Access Compliance Report

Public Rights-of-Way

(Pedestrian Signals)

Intersection ID: N/A	Main Street:	Cross Street: N/A	Location: N/A
ADA ID: 4E6BD4AD151C	Signal Type: One Push Button-Non APS	Overall Compliance: No	Severity Score: BTN 1: N/A BTN 2: N/A No BTN: N/A
Codes/Mitigation Info/Possible Solution		Field Measurements/Component Compliance

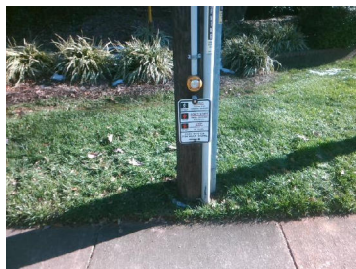
PROW/ADA: R404.2, R404.3, R406.2

Possible Solutions: Provide Push Button Extension. Remove and Replace Clear Space.
